Location:	1750 Broadway
Assessor's Parcel Numbers:	008 062301300
Proposal:	To construct a 37-story high-rise consisting of 307 residential units with 5,000 square foot of ground-floor retail space including a five-level parking garage above grade to be accessed from 19 th Street.
Applicant:	Rubicon Point Partners / Chris Relf
Phone Number:	(415) 500-6410
Owner:	1750 Broadway LLC
Case File Number:	ZP170064
Planning Permits Required:	Major Conditional Use Permit for buildings over 200,000 square feet in the CBD-P and CBD-C Zone; and Regular Design Review for new construction.
General Plan:	Central Business District
Zoning:	CBD-P / Central Business District Pedestrian; and CBD-C / Central Business District Commercial
Environmental Determination:	Environmental analysis under review
Property Historic Status:	Non-Historic Property
Service Delivery District:	Uptown
City Council District:	3
Date Filed:	07/19/17 / Revised Design Plans, Dated 02/09/18

Case File: ZPI70064
Applicant: Chris Relf
Address: 1750 Broadway
Zone: CBD-P, CBD-C
Height Area: Height Area 7, No Limit

Re: 1750 Broadway (Case File Number: ZP170064) – Response to Comments from January 31, 2018,
Design Review Committee Meet

GROUND FLOOR PLAN REVISED (02/05/2018)

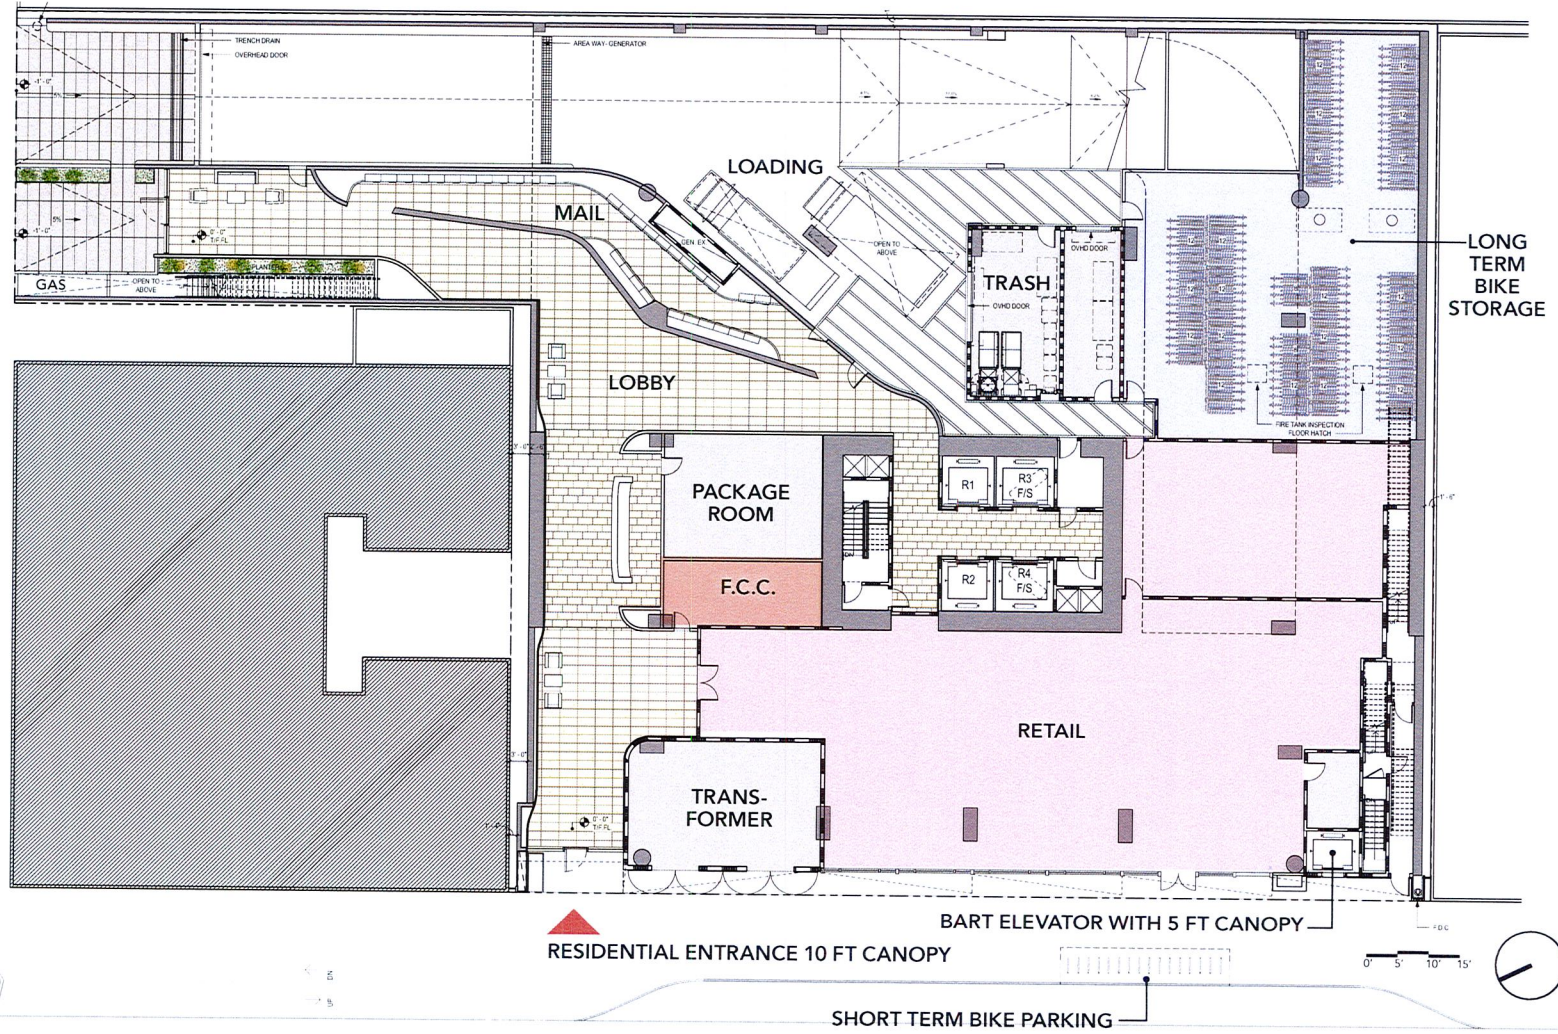
- *Distance the proposed short-term bicycle parking area from the north entry/exit BART station.*

We have revised the location of the short-term bicycle parking as shown in the updated site plan on page 15. We are in discussions with BART to confirm the required clearance from the station entry/exits and will comply to that requirement.

PODIUM FACADE - D.R.C. Revision Comments (01/31/2018)

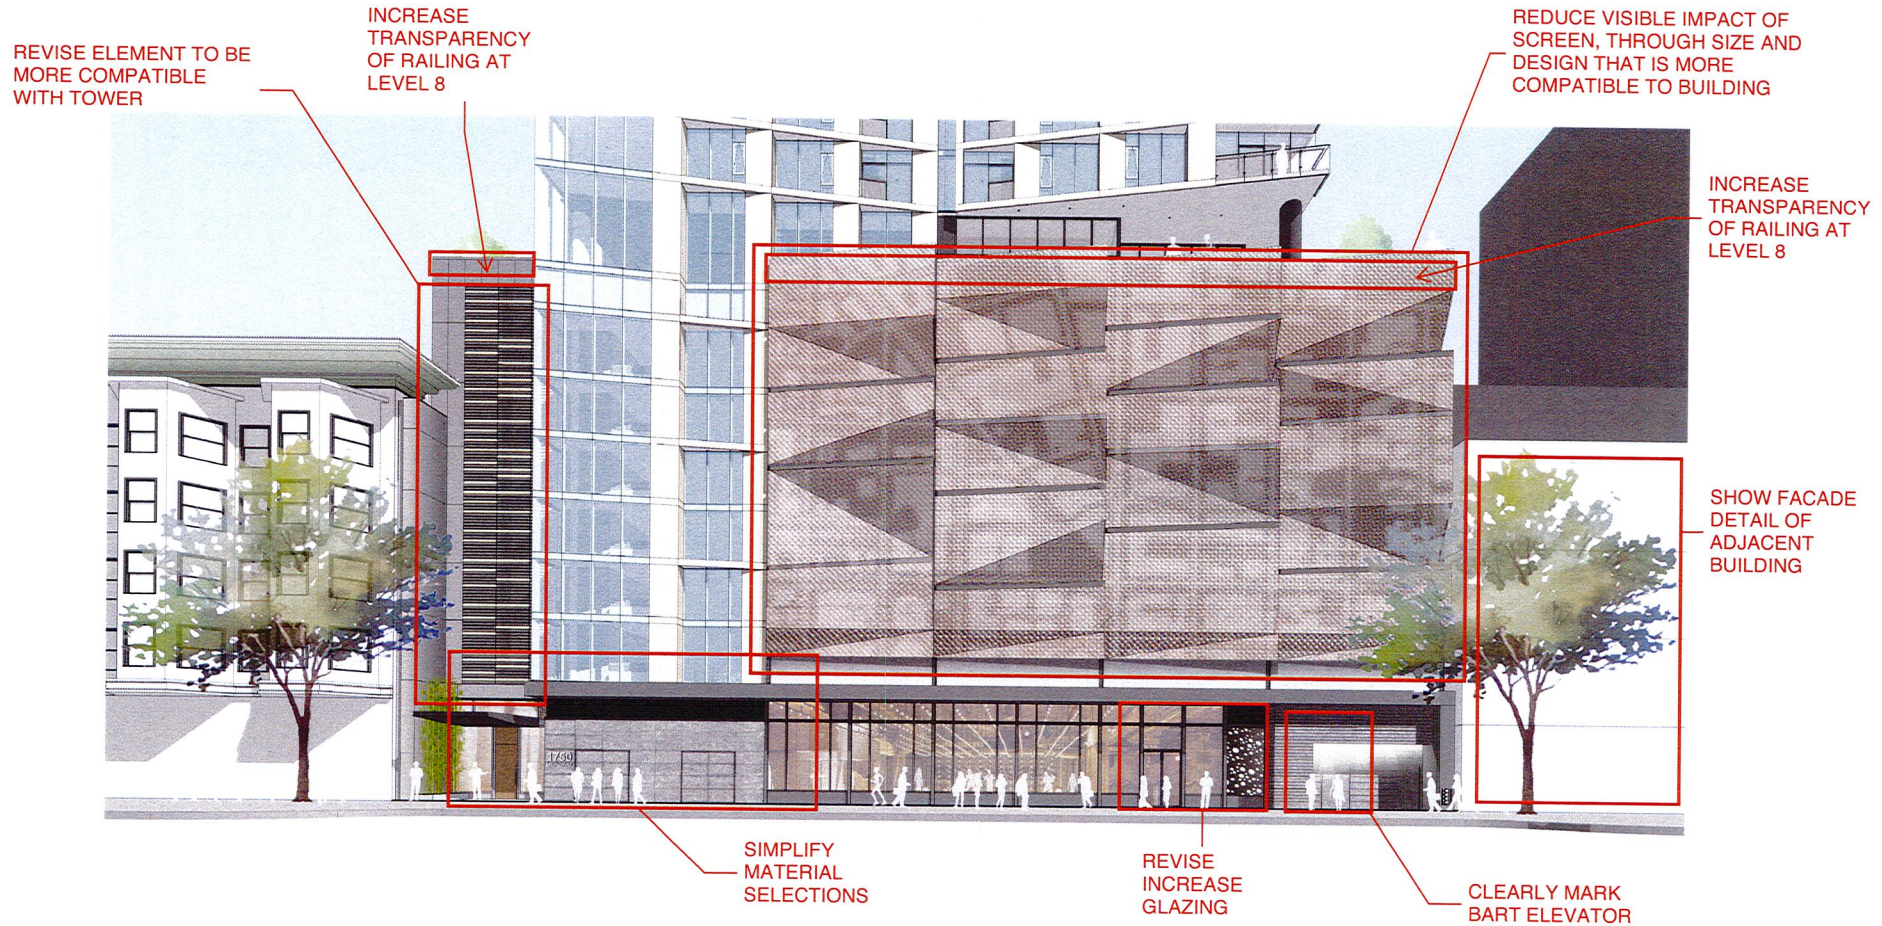
- *Develop further the façade wall (garage screen) in front of the six-level parking garage facing Broadway to create a better composition and scale that is compatible to the building tower and that includes interesting design details. Also, limit the verticality of the garage screen to the top of the 7 level. The terrace on the 8 level should use instead a clear glass railing for transparency.*

In response to this comment, and similar comments, made by the DRC members, the garage screen has been further refined. Updated screen images showing the mapping concept are attached and provide further context to the garage screen design. The terrace on level 8 (now 7) has also been revised to include a clear glass railing and clerestory glass has been added above the canopy on the 2nd floor to provide a transition between the garage floor and screen. In response to comments regarding the overall size of the screen and that it was too "imposing" to the street, a level of parking has been reduced from the project and the ground floor height has increased from 18 feet to 20 feet creating a grand and inviting

Attached to this response are four (4) options regarding the screen massing and garage louvers. The four (4) options reflect a refinement in design and respond to the comments received. The team's preferred option is option 1B as shown on page 29.

PODIUM FACADE - REVISED DESIGN (02/05/2018) - OPTION 1B

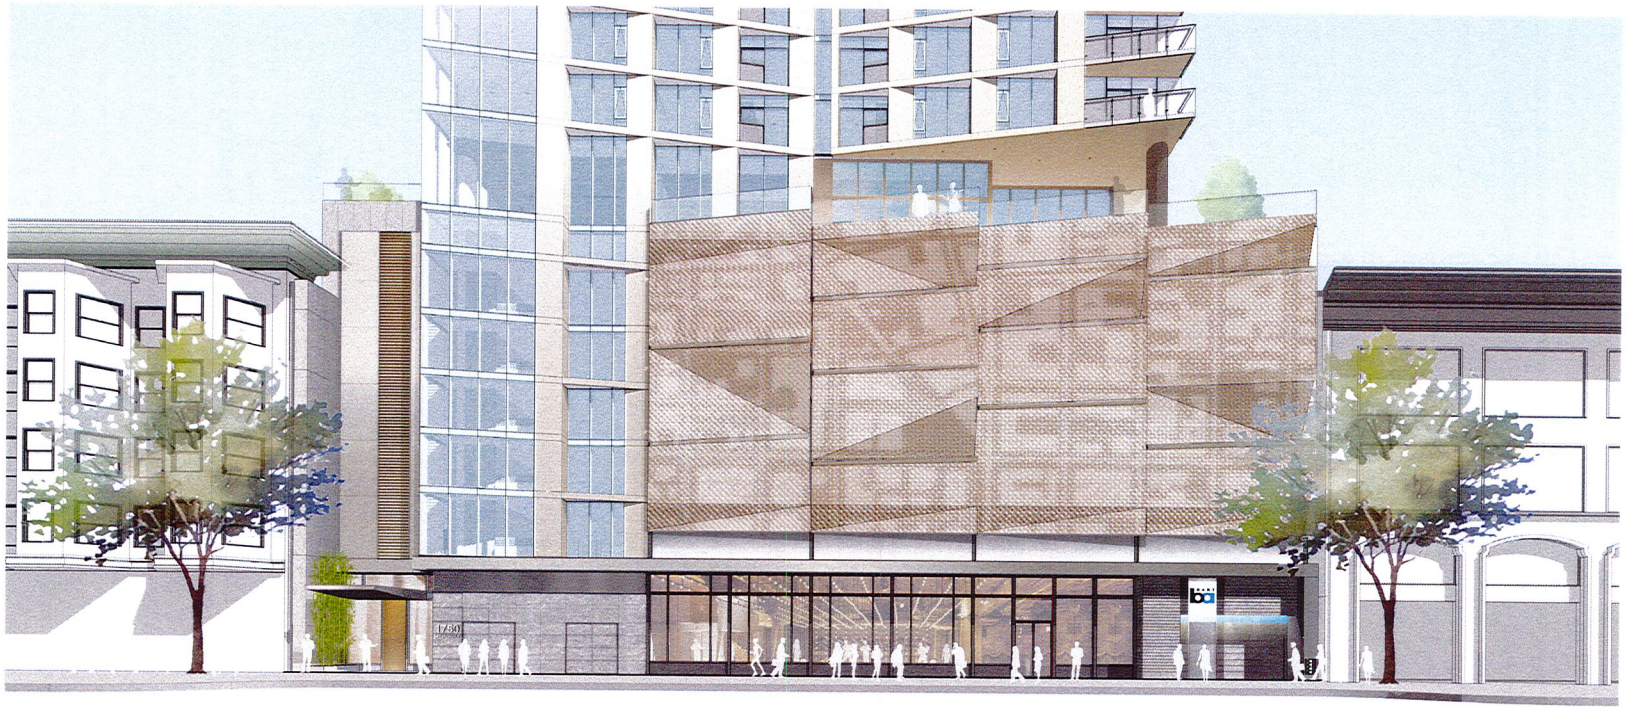
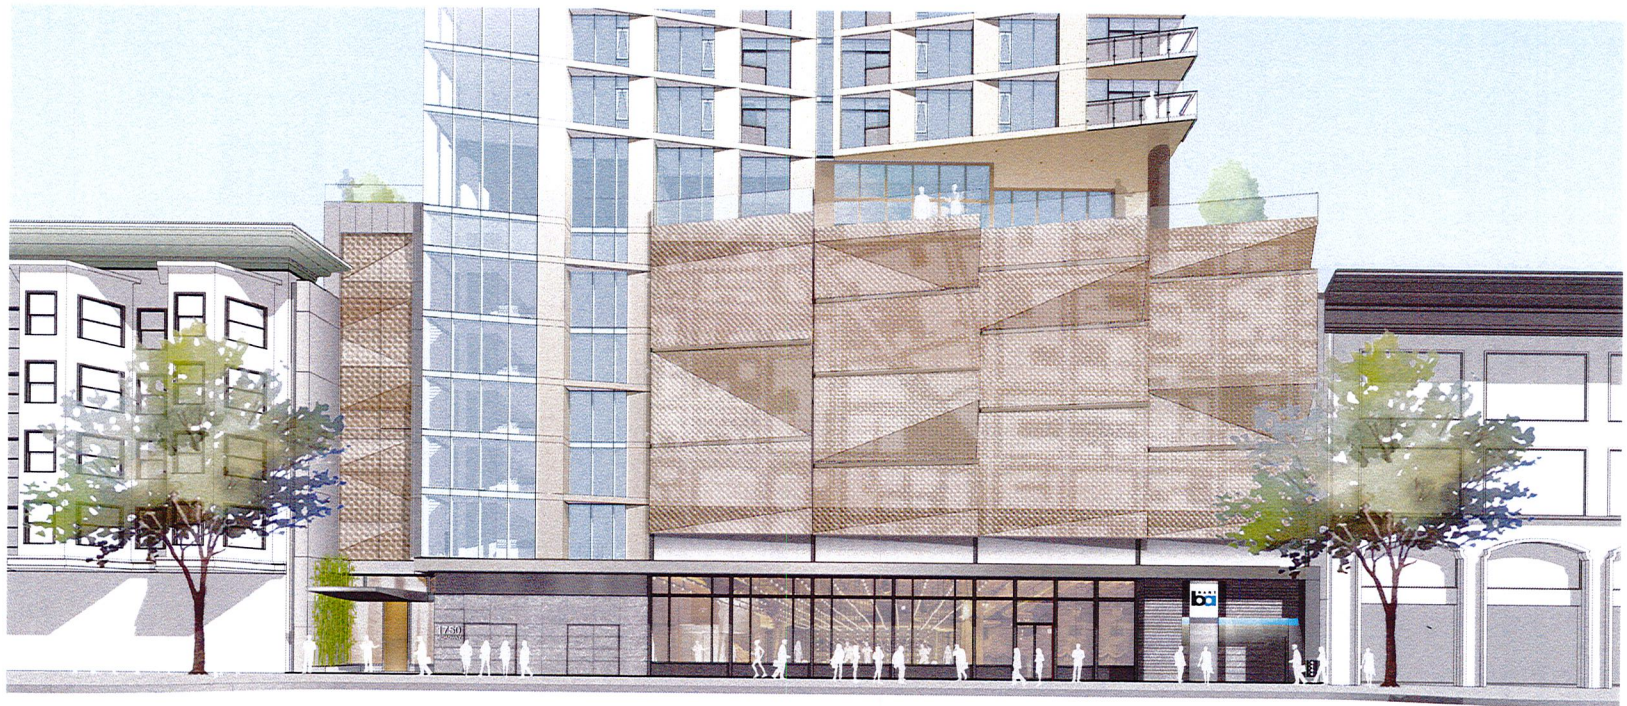
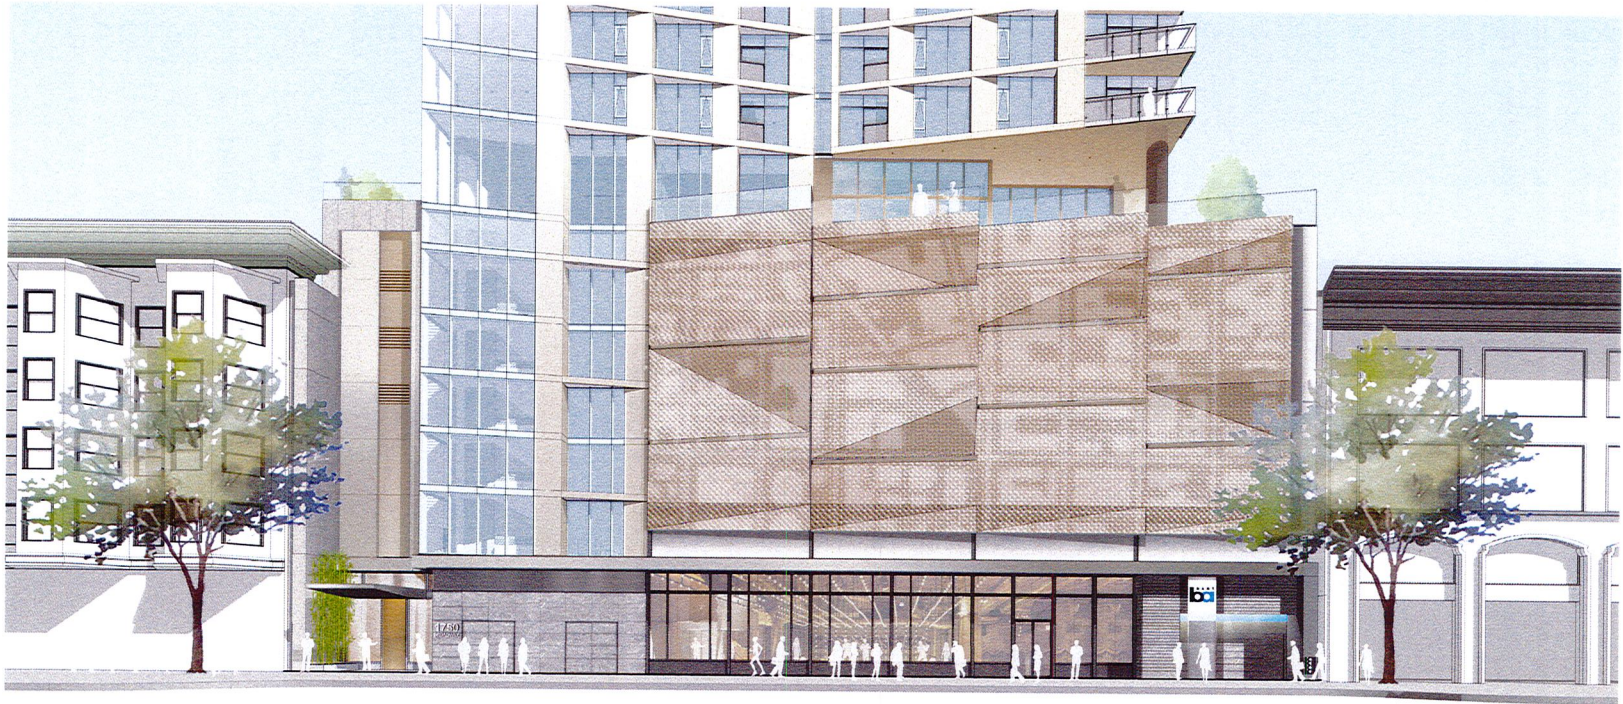
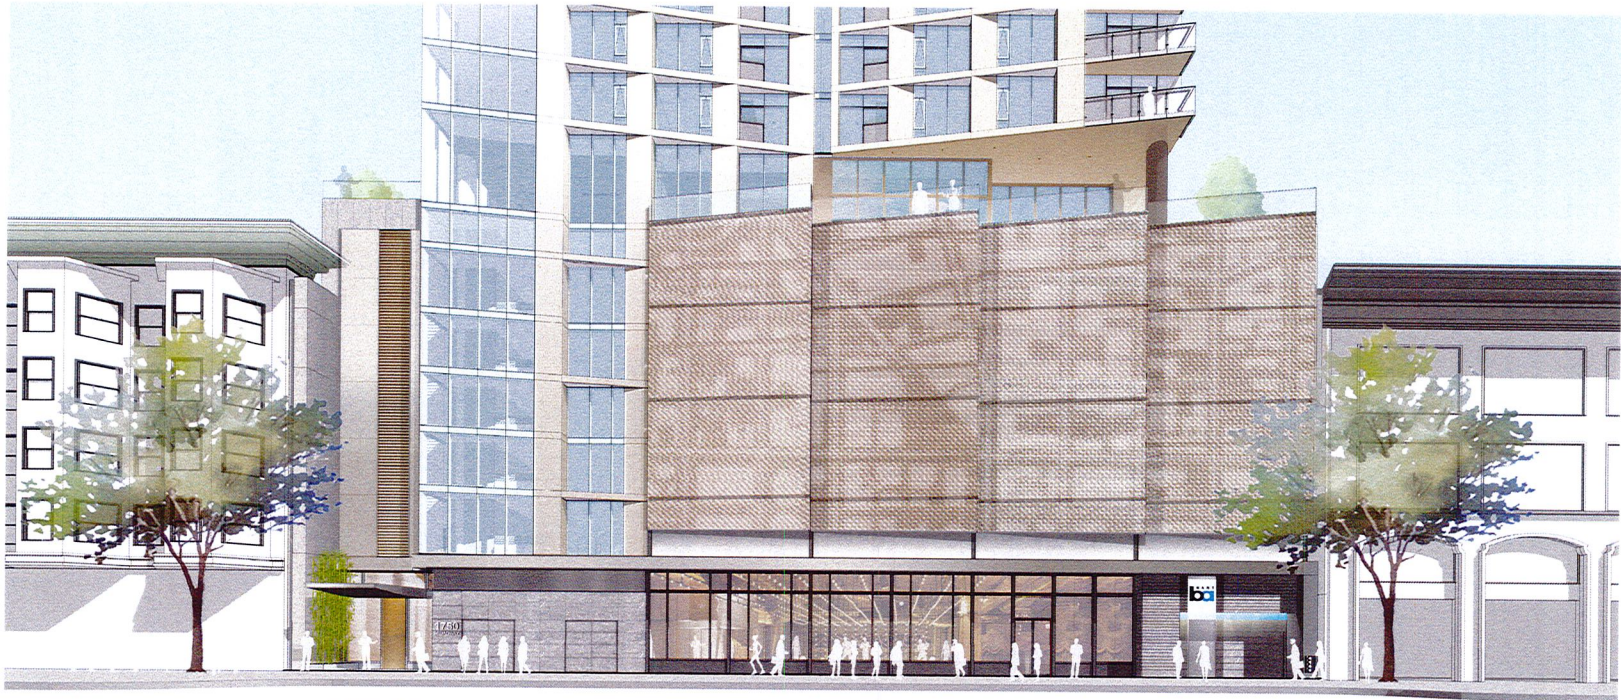
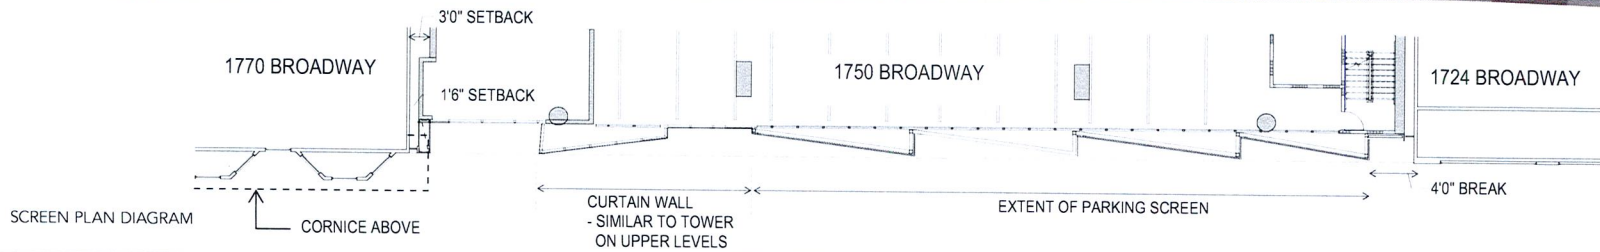
- 1) Scale the garage façade to create transition and consistency with the building and street;
- 2) Develop the ground floor to create visual continuity and transparency along the street frontage;
- 3) Simplify the exterior material treatments to relate to the building and context of the area;
- 4) Consider recessing the BART elevator entry, but keep it visible to public view;
- 5) Show the adjacent building to the south and include historic photos of the project site; and
- 6) Include views of the project and downtown skyline from the Bay Bridge; and
- 7) Demonstrate communication with the affected tenant of the existing facility.

1. Scale the garage façade to create transition and consistency with the building and street-
The revised plans show five design options illustrating the building façade along Broadway. The applicant's preferred design is Option 1B on page 28. This option shows the height of the garage was lowered from six to five levels. Also, the top portion of the garage screen was replaced with a glass railing for the terrace on level 7. The project includes white opaque clerestory windows above the retail space. Staff believes that these changes provide relief from the garage screen, thus improving the transition between the podium and the ground-floor and provides a better design consistency.

1770 LOT LINE ELEVATION

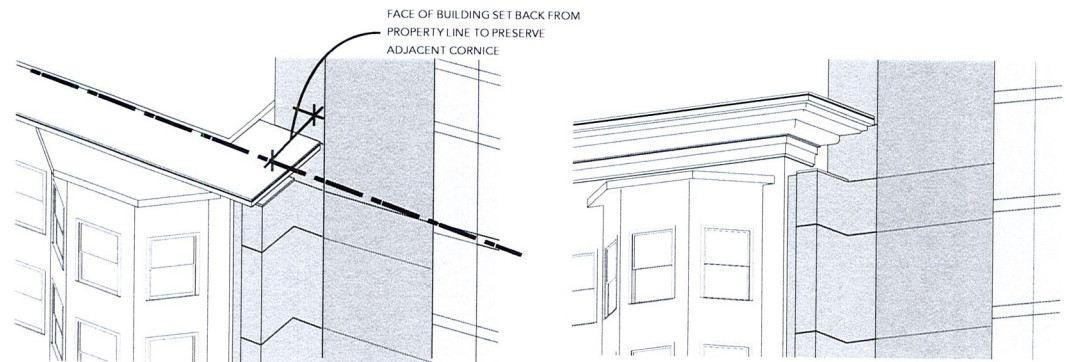
- *The north, south and east garage walls need further massing relief as these are close to residential unit windows and section of blank garage walls would be seen from 19th Street.*

To address concerns regarding the blank garage walls, the project is proposed to commission a mural to be located along these frontages to provide interest and relief. In addition, the building has been setback three (3) feet from the property line to allow additional light and air at property line windows. Images of the proposed mural are shown on page 34 of attached exhibit, but we will work with our neighbors to create a design and feel that addresses their concerns and creates the visual relief requested. Page 40 also shows the elevation view from 19th Street with the garage louvers and garage wall architectural treatment to depict the future streetscape from this corridor.
